Name of Document: VRP Revised Compliance Status Report

Subject: Response to EPD Comments
Voluntary Remediation Program Compliance Status Report
Savannah Electric - Plant Kraft, HSI Site No. 10415
155 Crossgate Road, Port Wentworth, Chatham County, Georgia

Subject: Revised Voluntary Remediation Program Compliance Status Report
Georgia Power Company Plant Kraft
HSI Site 10415
155 Crossgate Road
Port Wentworth, Chatham County, Georgia

**GEORGIA POWER COMPANY PLANT KRAFT
155 Crossgate Road
PORT WENTWORTH, CHATHAM COUNTY, GEORGIA
HSI Site 10415**

**Figure
4**

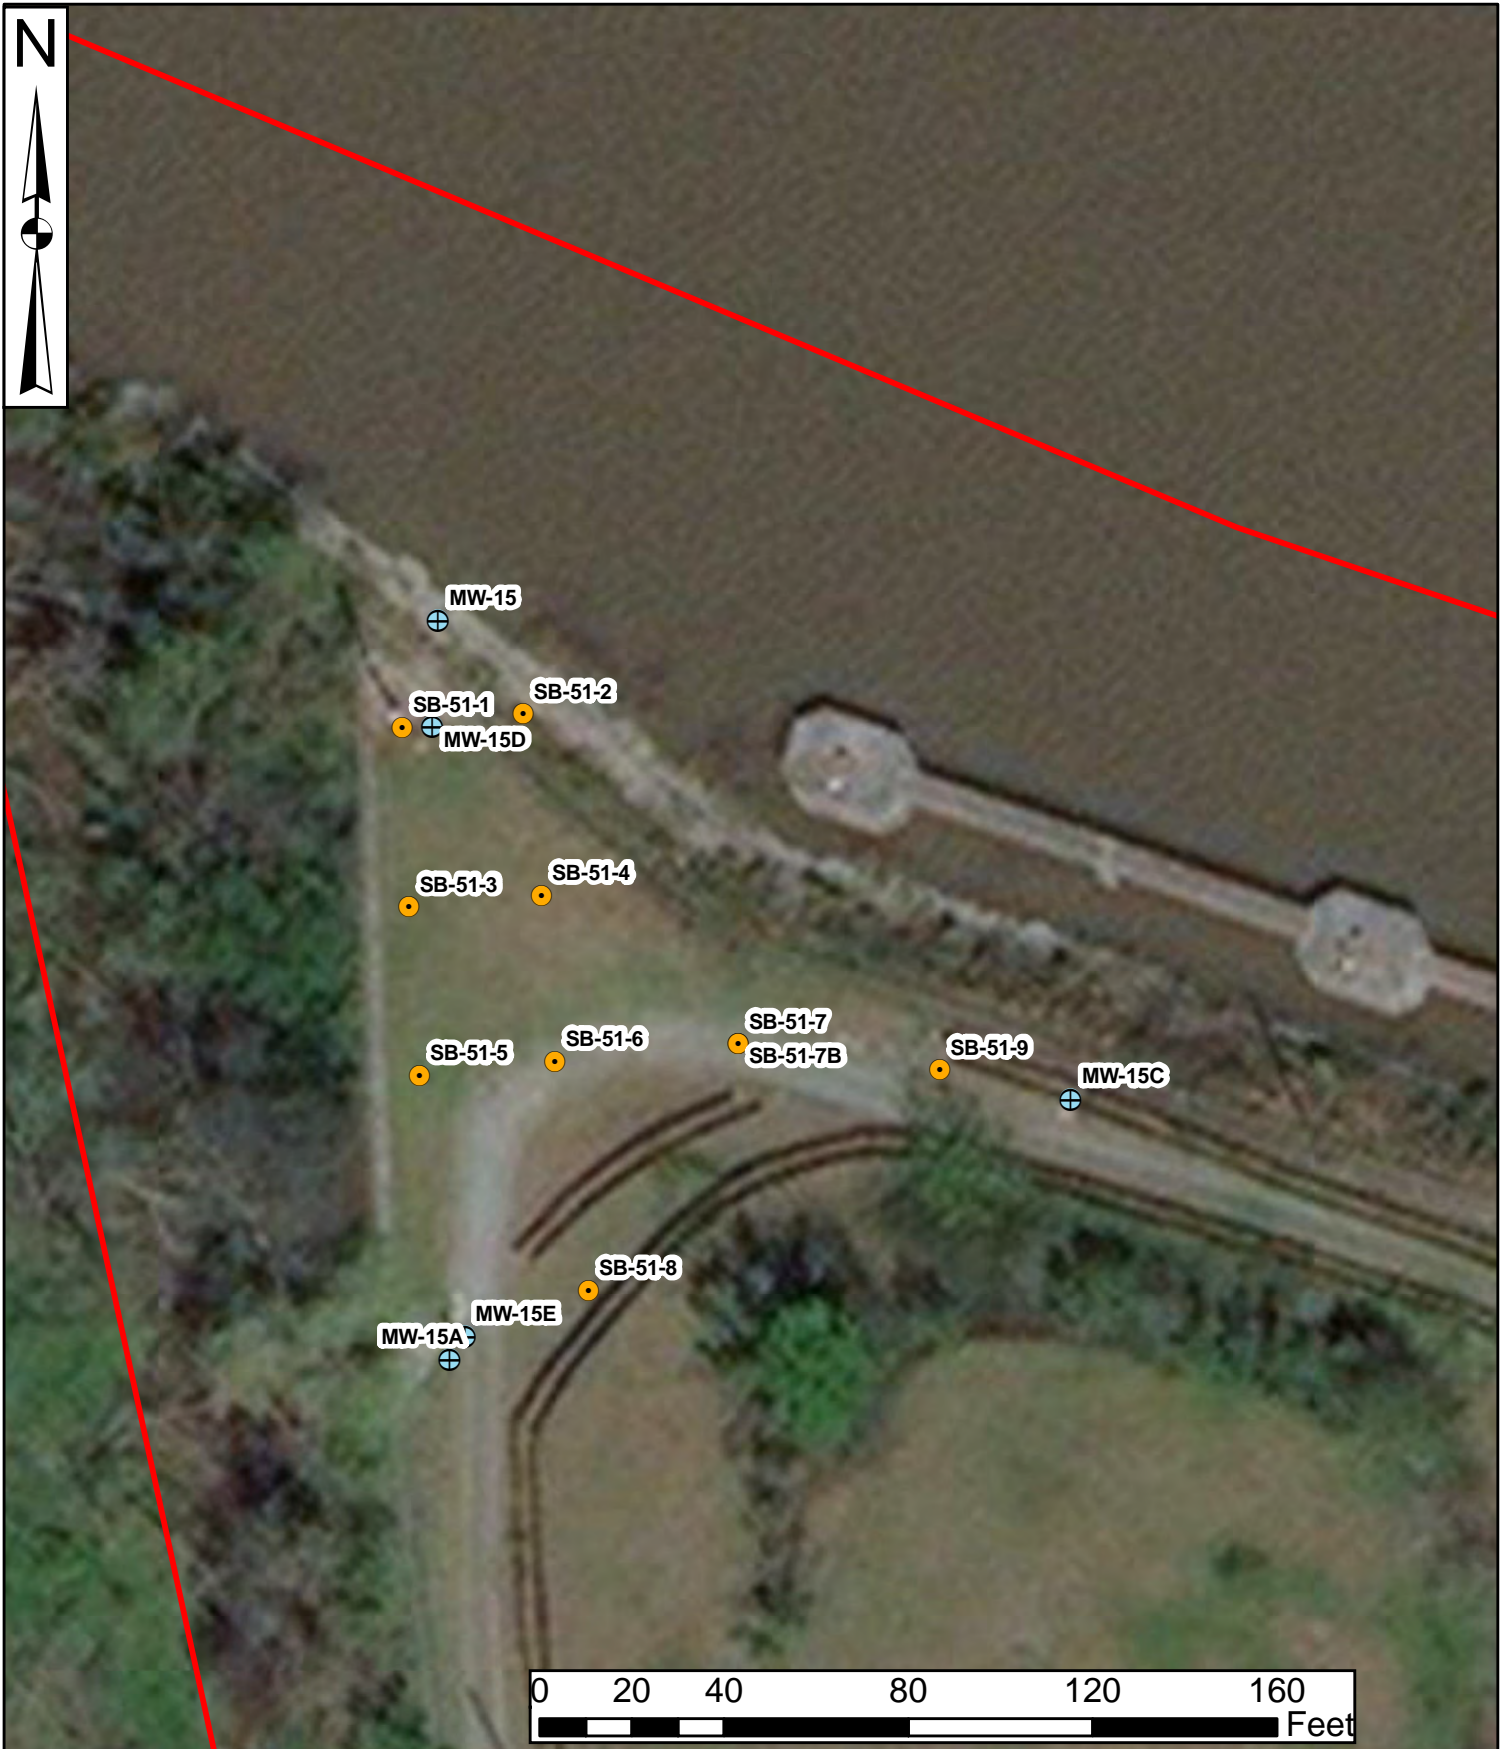
4. Additional groundwater characterization is requested southeast of the Potential Buried Drum — Storage Building Expansion Area (Location 23 on Figure 4). Samples should be collected and analyzed for metals, VOCs, SVOCs, and PCBs.

Same response as Comment #3. Four additional groundwater monitoring wells were installed, and samples analyzed for metals, VOCs, SVOCs, and PCBs. Discussion is presented in Section 3.1.2 on page 20 and Section 3.3.2 on page 21. The results are presented in Section 3.4.4 on page 26. The results are summarized on Table 4A and shown on Figure 22.

Figure
 22

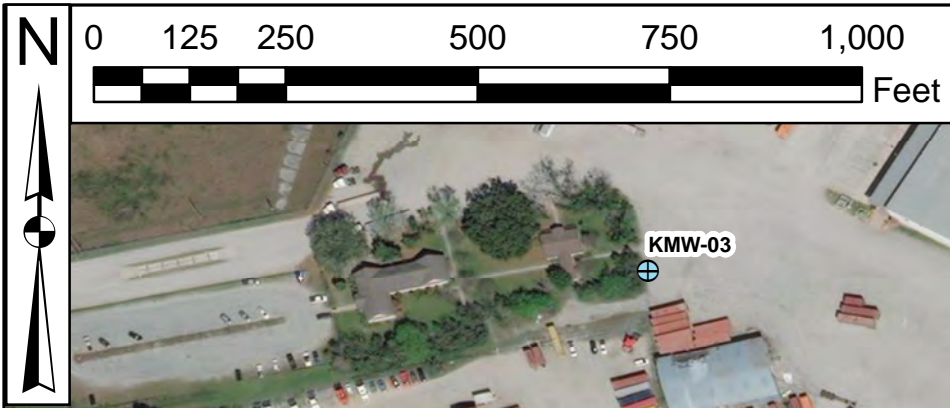
1. An additional groundwater monitoring event should be conducted to further evaluate radium concentrations and geochemical conditions in groundwater in the vicinity of the former ash pond area.

confirmation groundwater characterization is requested downgradient of the inert landfill for VOCs, SVOCs and PCBs. In the event, that existing monitoring wells MW-15D(R), MW-15C(R), and MW-15A (R) are downgradient of the observed waste materials, please provide VOC and PCB analysis for these wells as SVOC analysis has been historically performed.

An additional groundwater monitoring event was performed, and the results are presented in Section 3.4.1.3 on page 24. The results are summarized on Table 5 and shown on Figure 22.

Additional groundwater sampling for VOCs and PCBs was performed, as discussed in Section 3.1.2 on page 20. The results are presented in Section 3.4.2 on page 26. The results are summarized on Table 4A and shown on Figure 22.

Four additional groundwater monitoring wells were installed, and samples analyzed for metals, VOCs, SVOCs, and PCBs. Discussion is presented in Section 3.1.2 on page 20 and Section 3.3.2 on page 21. The results are presented in Section 3.4.4 on page 26. The results are summarized on Table 4A and shown on Figure 22.
